Section 92 Response Attachments

Attachment 6 - Traffic

11117-4
12 December 2012

**Watercare Central Interceptor
Transport Response to Section 92 Request for Further Information**

4a

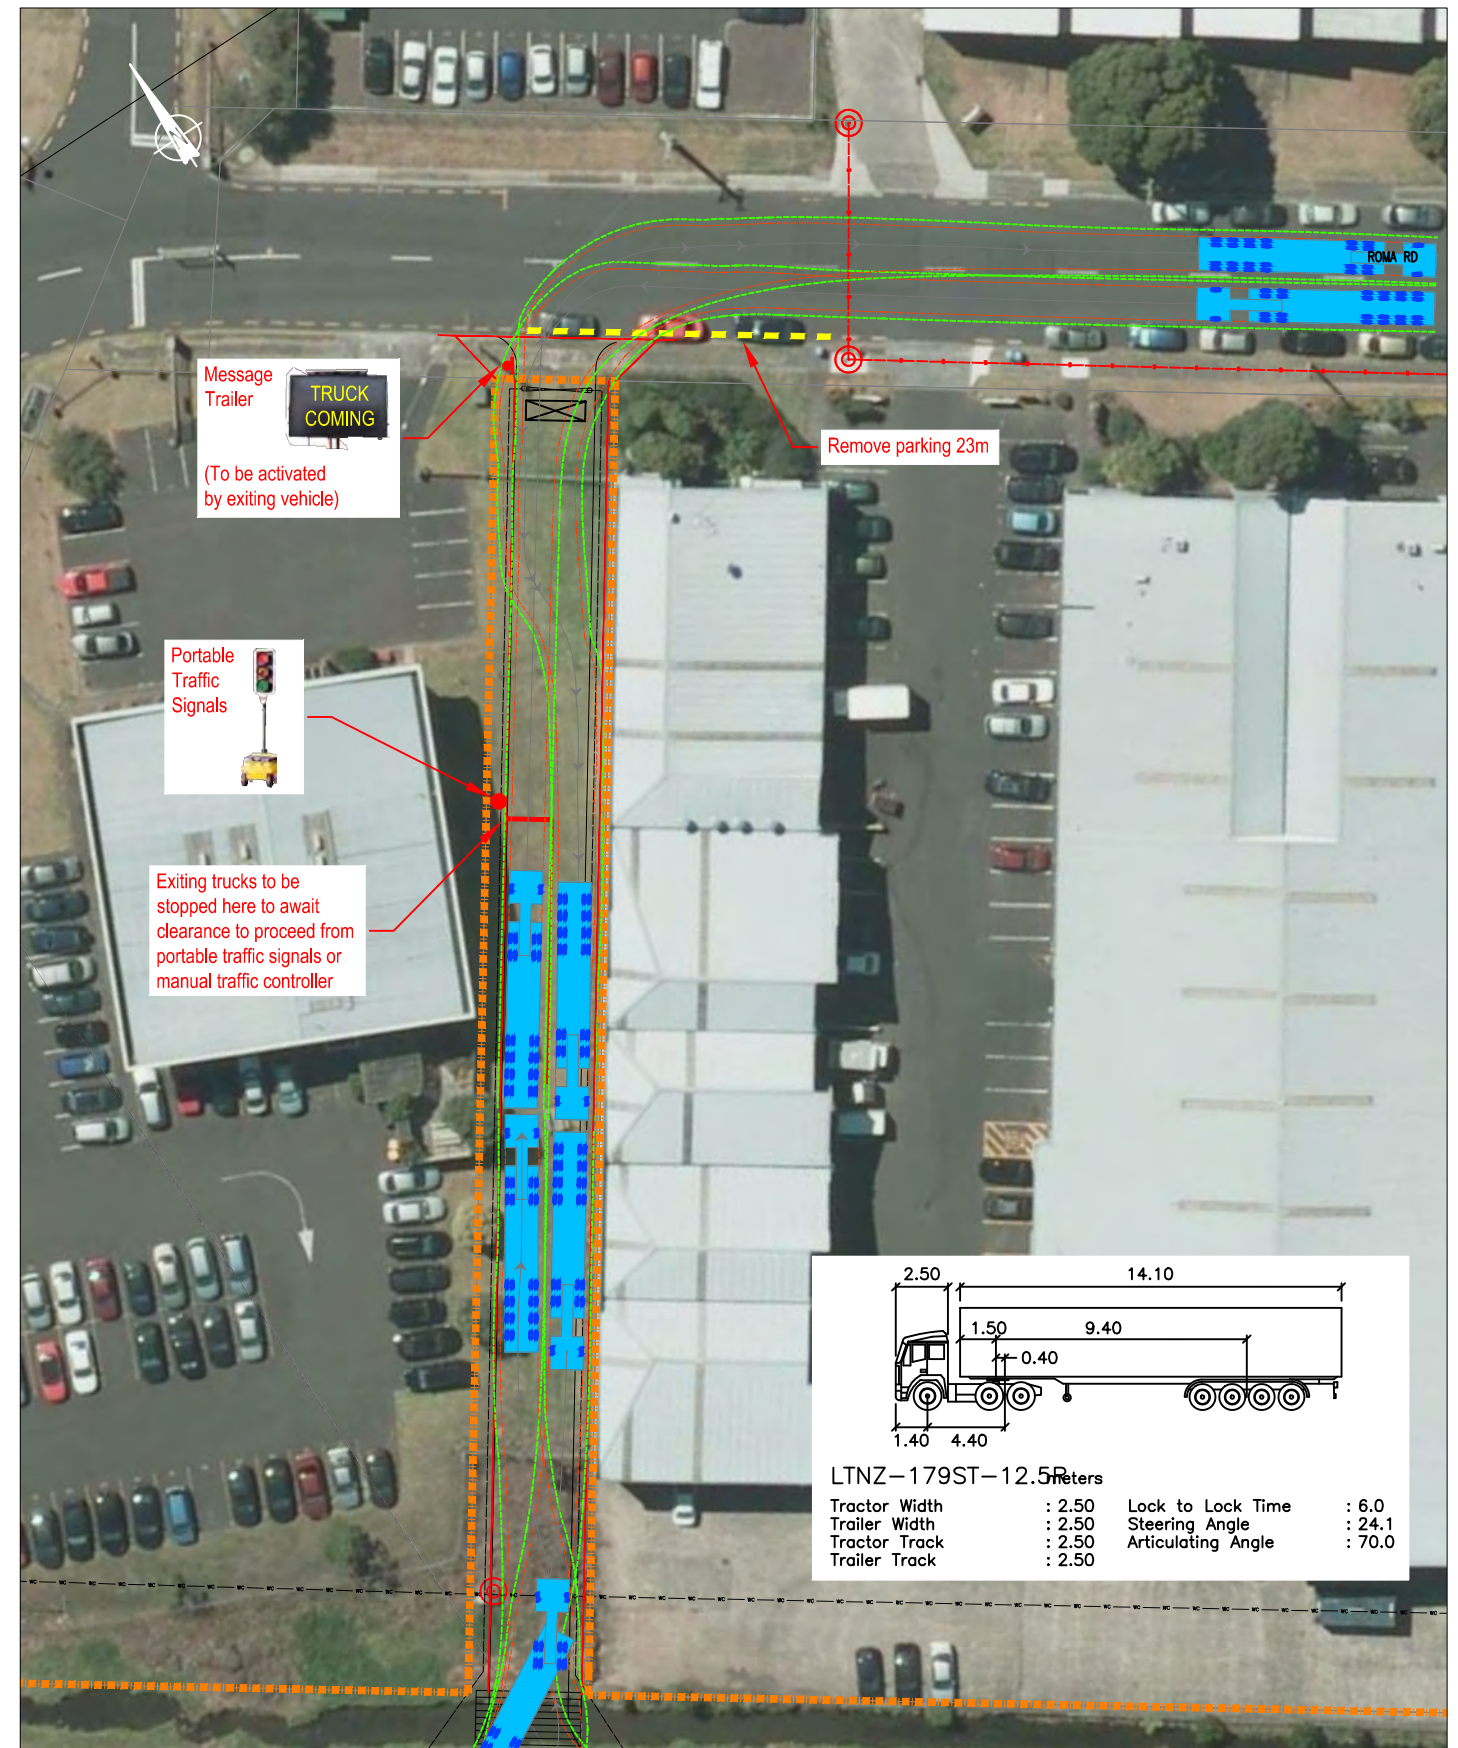
- *More detail needs to be provided in terms of how access to the northernmost 36 public parking spaces is to be maintained, while still fencing the proposed construction area.*

Figure 4a attached in this letter details the temporary arrangement of the public car park to maintain access to the northern parking spaces.

As shown in Figure 4a total of 23 parking spaces would be removed from public use during construction. This includes 12 spaces in the north-western parking aisle, and 11 spaces in the parking areas immediately to the east of the parking aisle.

Keith Hay Park (AS5) - Truck Tracking

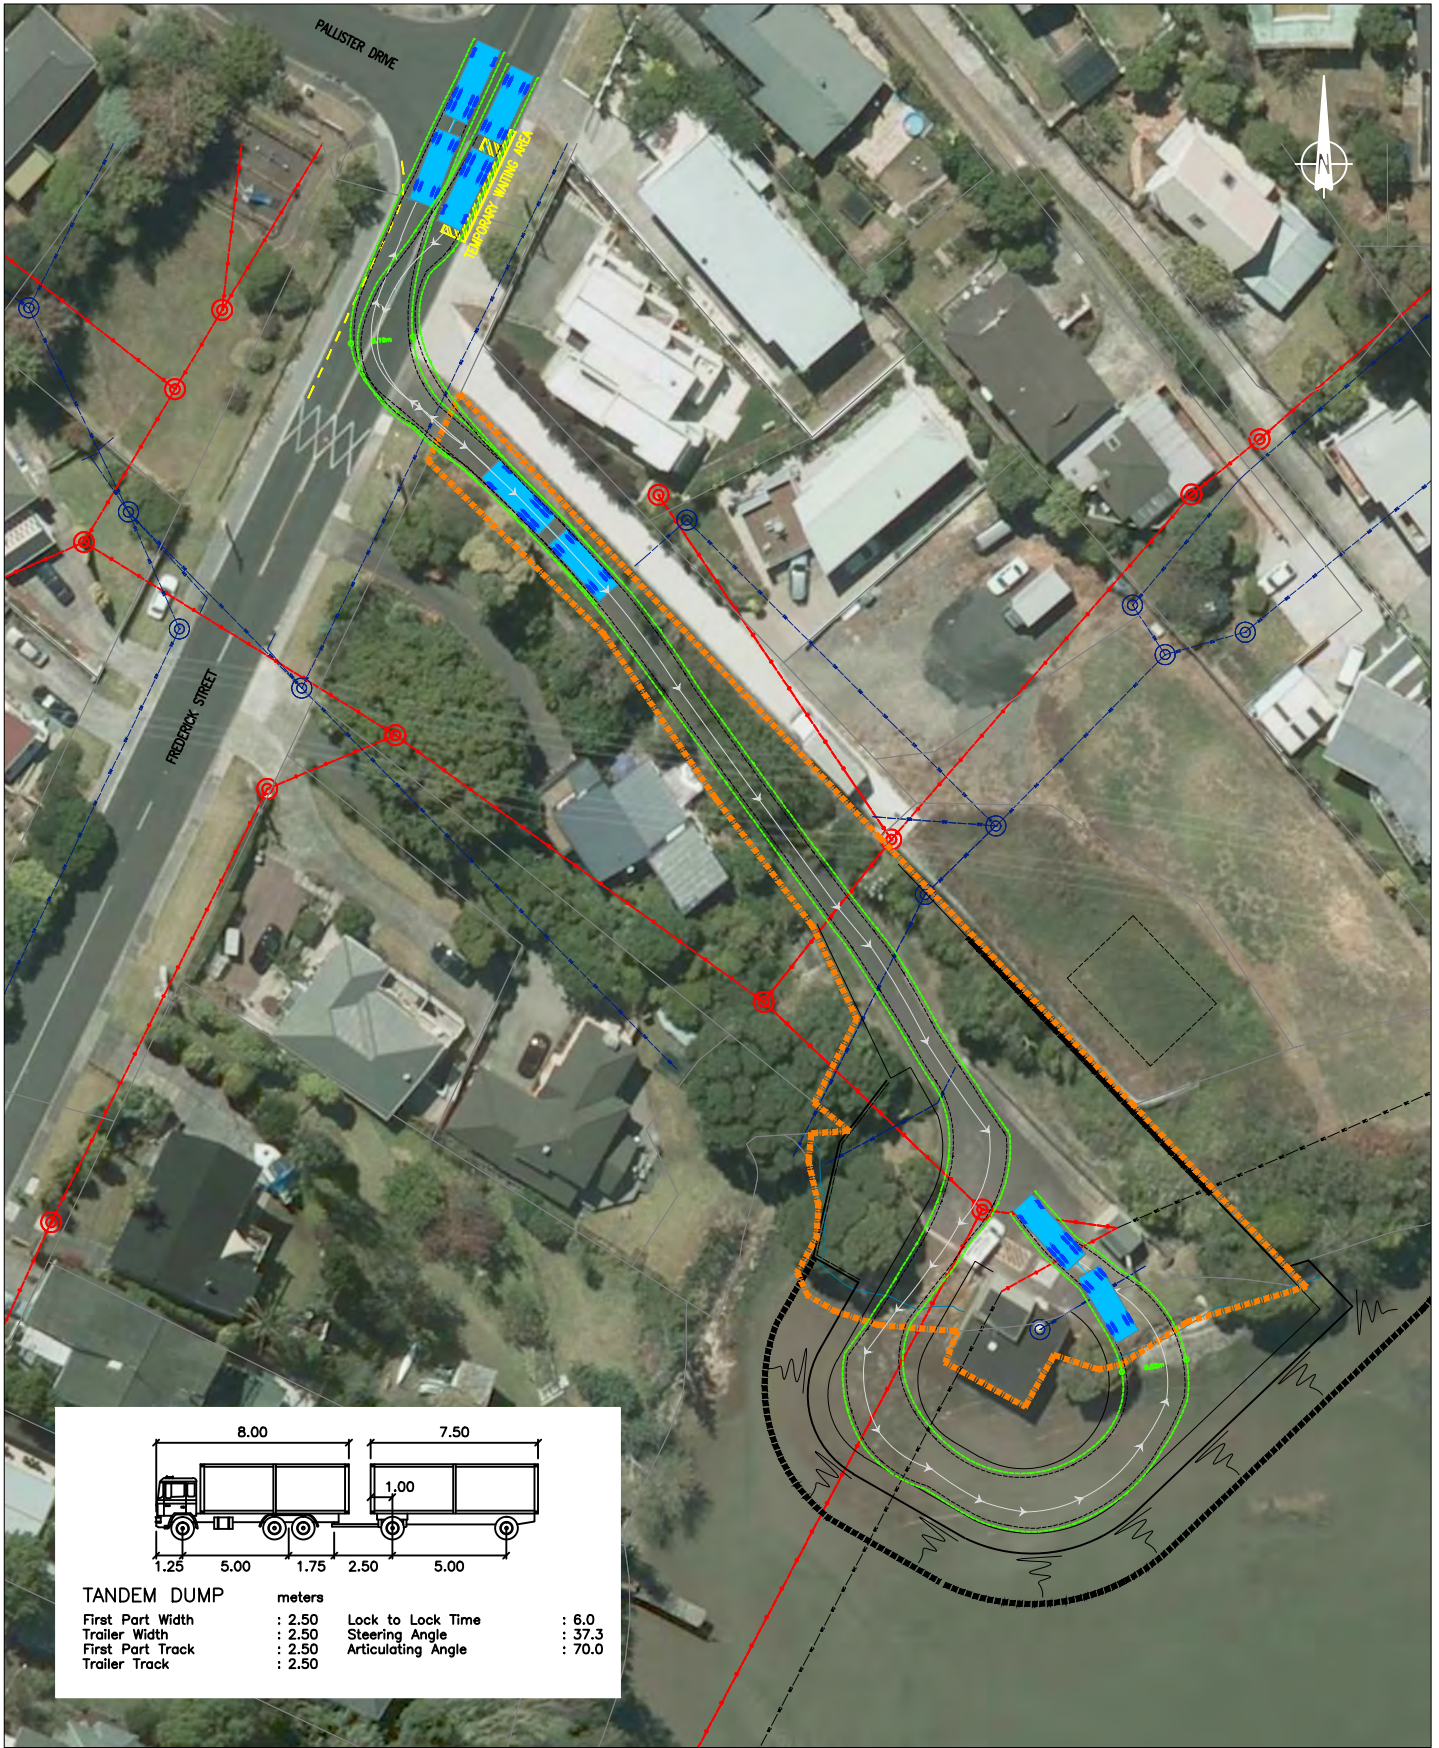
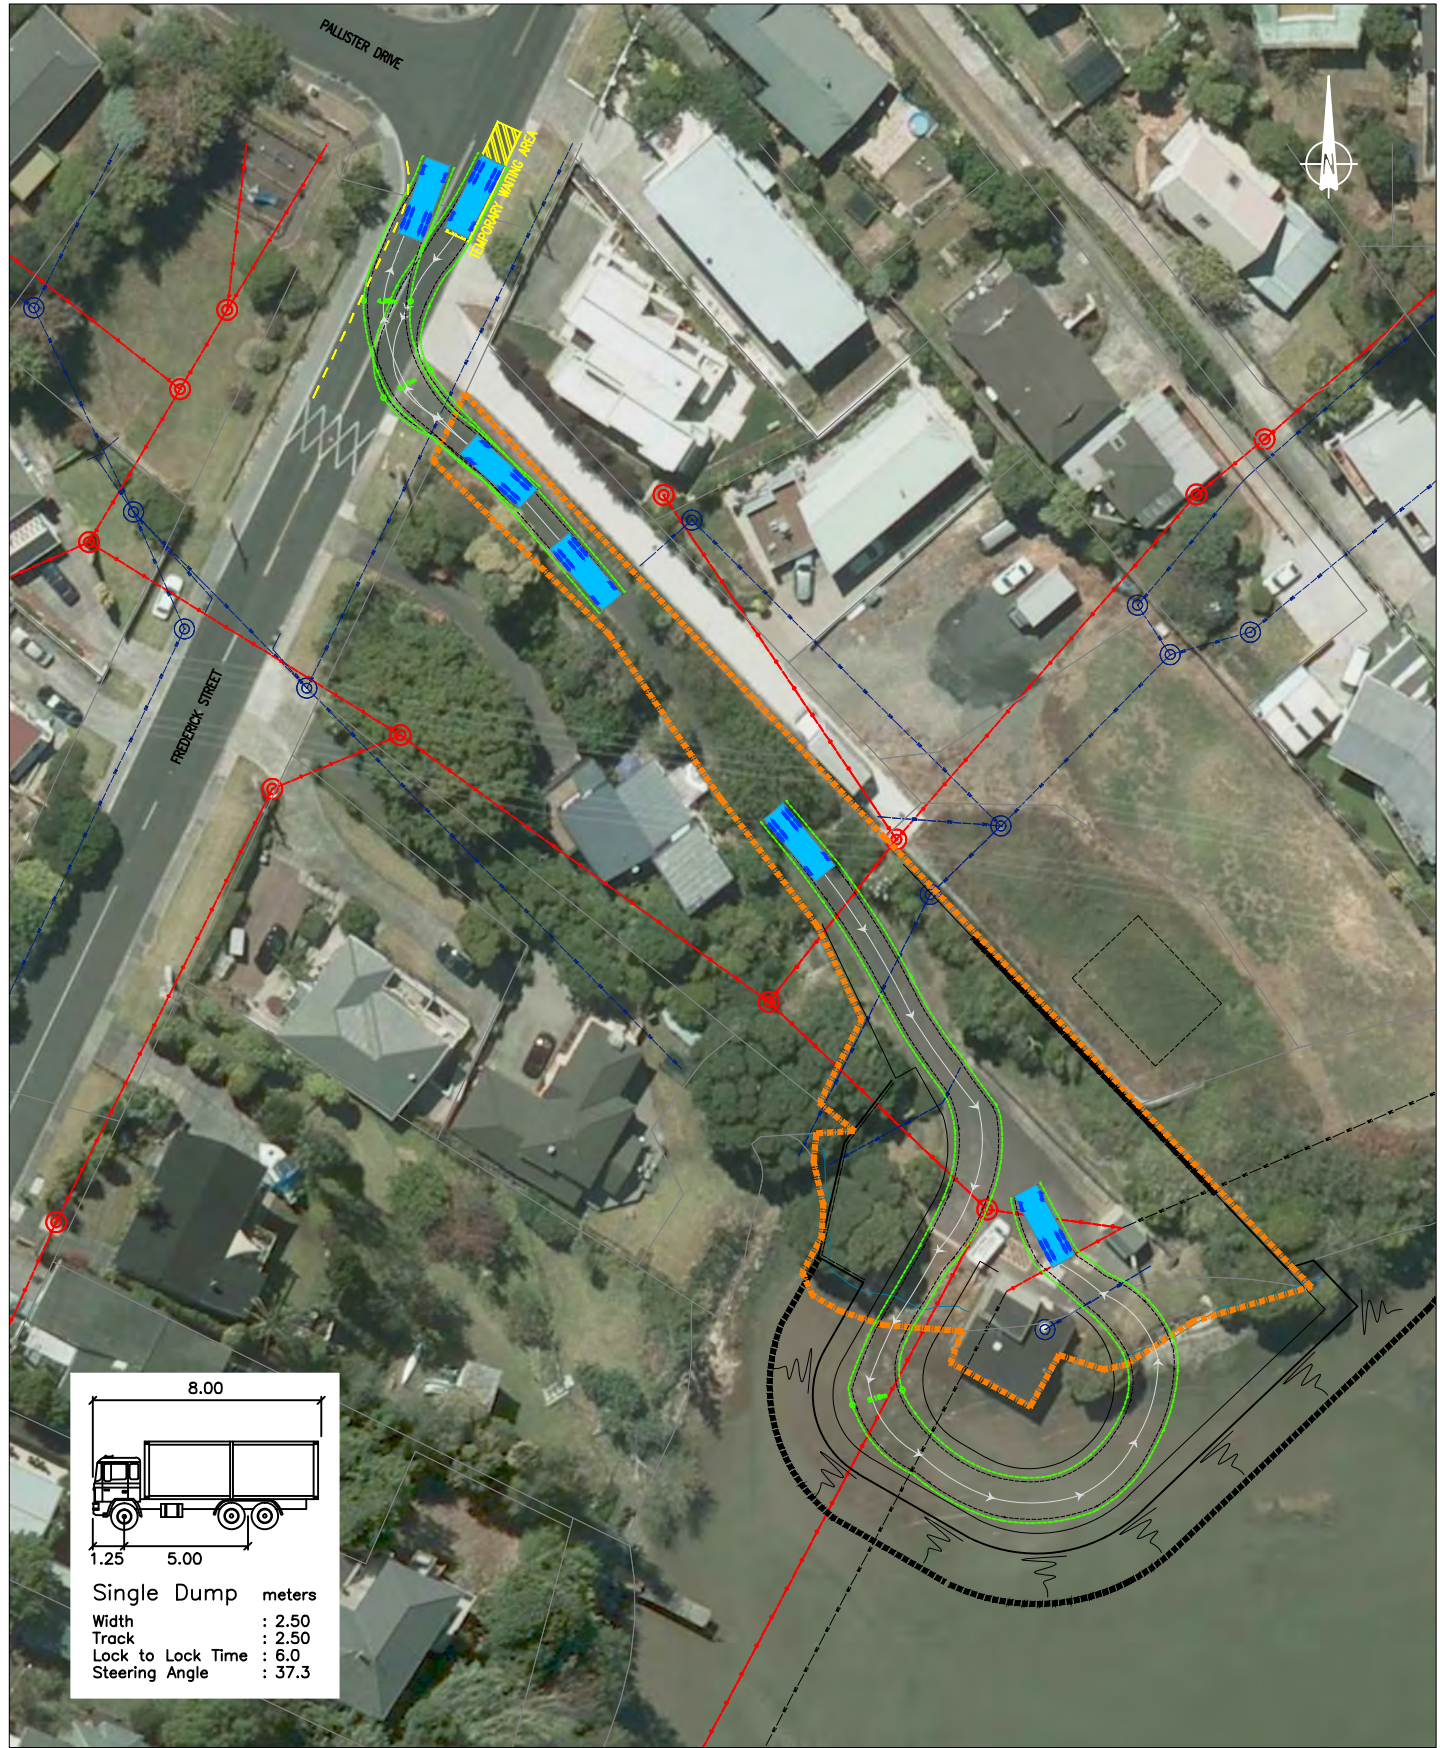
- *Provide a truck tracking assessment for access from Rainford Street, including access over the bridge and turnaround on site.*

A tracking curve demonstrating access into the site from Rainford Street is attached as Figure 14a.

24.v2

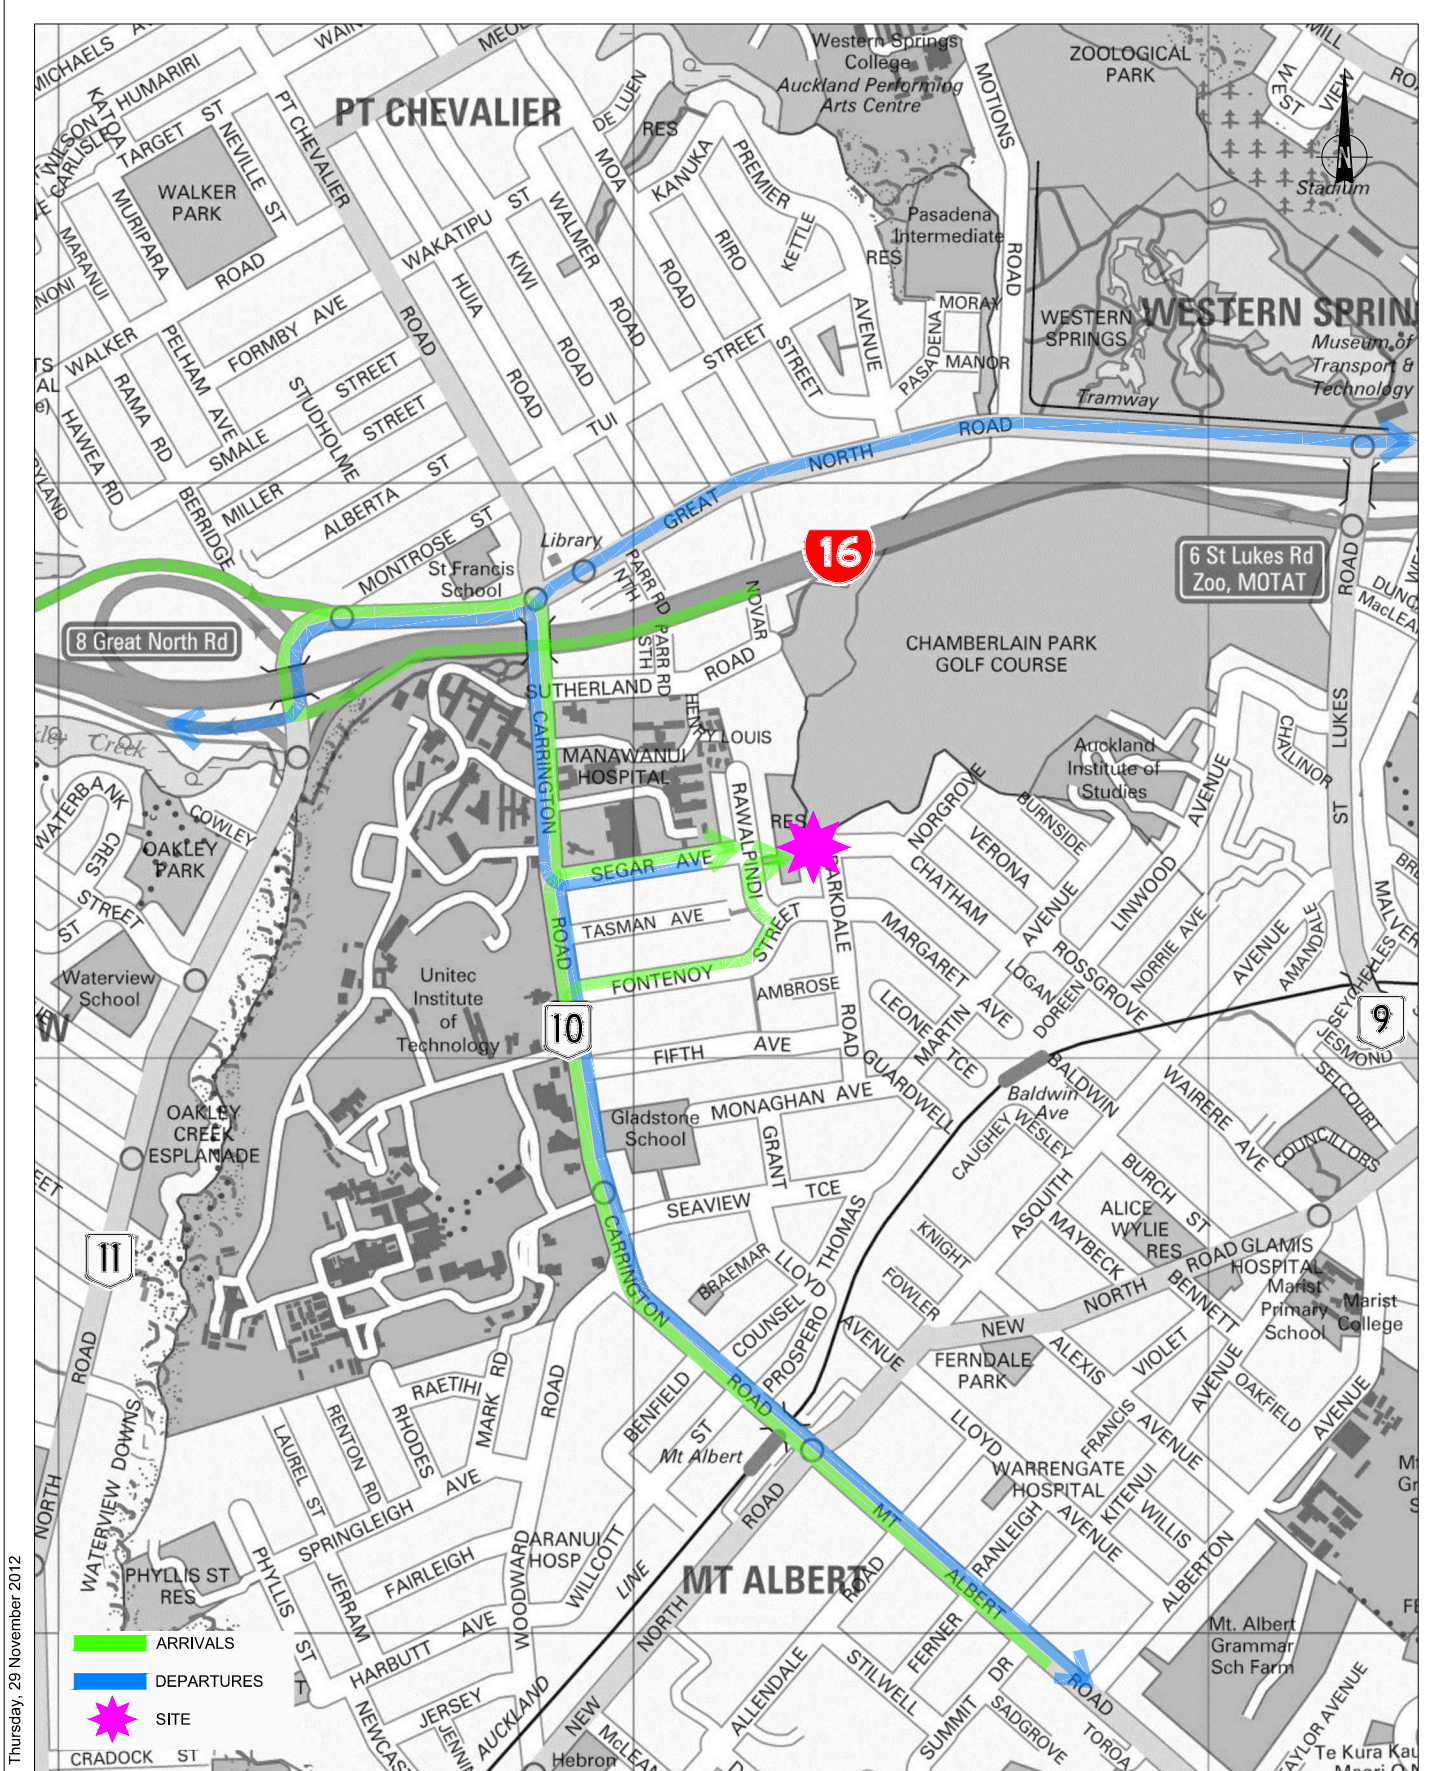
- *Confirmation is sought regarding whether or not the existing vehicle crossing is to be widened to accommodate the tracking as shown in the plans (Figure 24 of the TIA).*

The site access will be widened as per the tracking curve diagram shown on Figure 24 of the TIA report. A vehicle crossing of some 6m will be required in order for heavy vehicles to access the site safely. It is considered to be an acceptable distance and pedestrians will be able to cross the site access safely as a continuous footpath is provided across the site access.

Four spaces would be removed to enable safe truck access. An updated tracking curves diagram (Figure 24 version 2) shows the extent of temporary parking removal. As explained previously, we consider that the total temporary loss of parking can be accommodated without resulting in any significant effects.
